CSP 26-003KB (BP022) – ADDENDUM No.01
Gym Renovations and Additions

Fort Bend Independent School District
2023 Bond Program

Addendum Number One (01)
TO PLANS AND SPECIFICATIONS FOR
CSP 26-003KB BP022 Gym Renovations
Fort Bend ISD
STANTEC Project Nos.: 214001246

October 10, 2025

2 **PLUMBING ENLARGED DEMOLITION PLAN - LEVEL 1 - ART 306**
Scale: 1/4" = 1'-0"

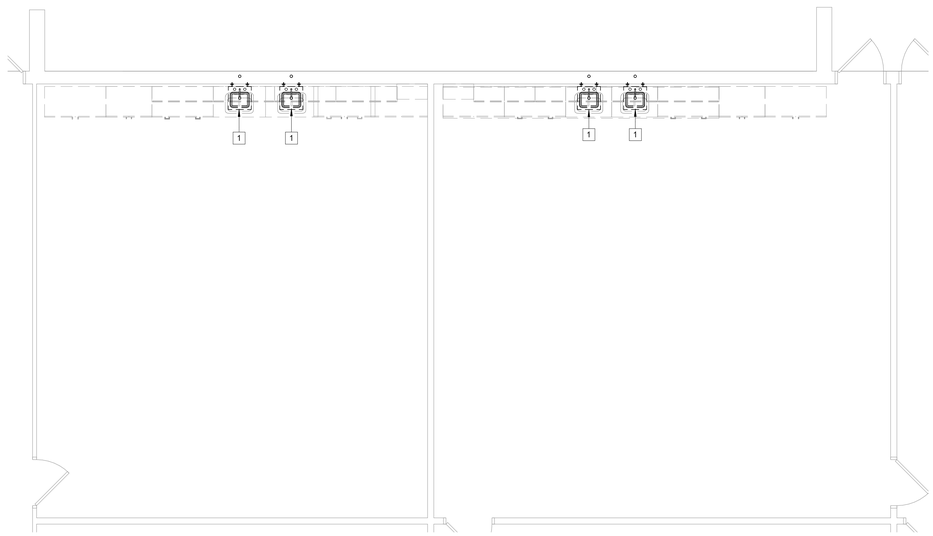
i. SHEET P001-RES PLUMBING ENLARGED DEMOLITION FLOOR PLANS.
i. ADDED KEYED NOTE # 2 TO ART 306 SPACE.

2 **PLUMBING ENLARGED PLAN - LEVEL 1 - ART 306**
Scale: 1/4" = 1'-0"

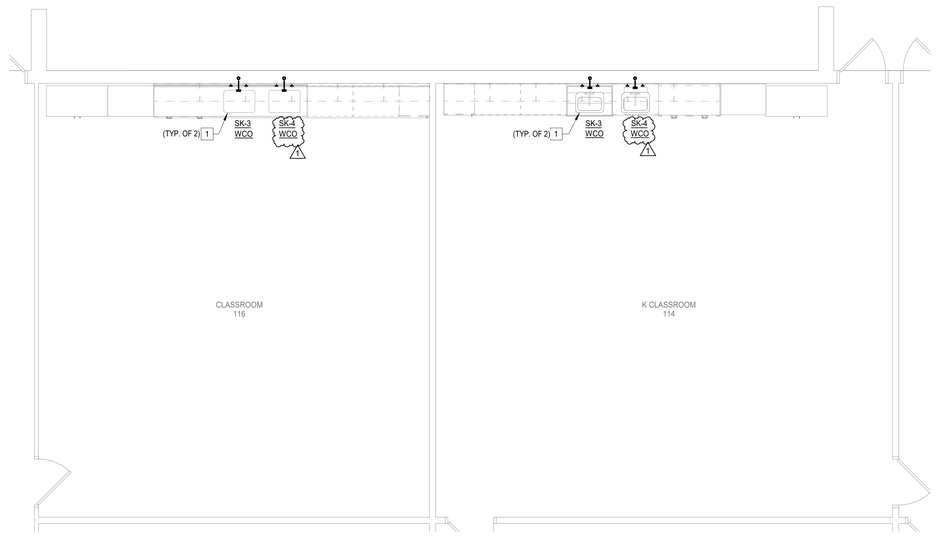
k. SHEET P301-RES PLUMBING ENLARGED FLOOR PLANS.
i. REVISED ONE SINK AT CLASSROOM 116 & K CLASSROOM TO NON T.A.S. COMPLIANT.
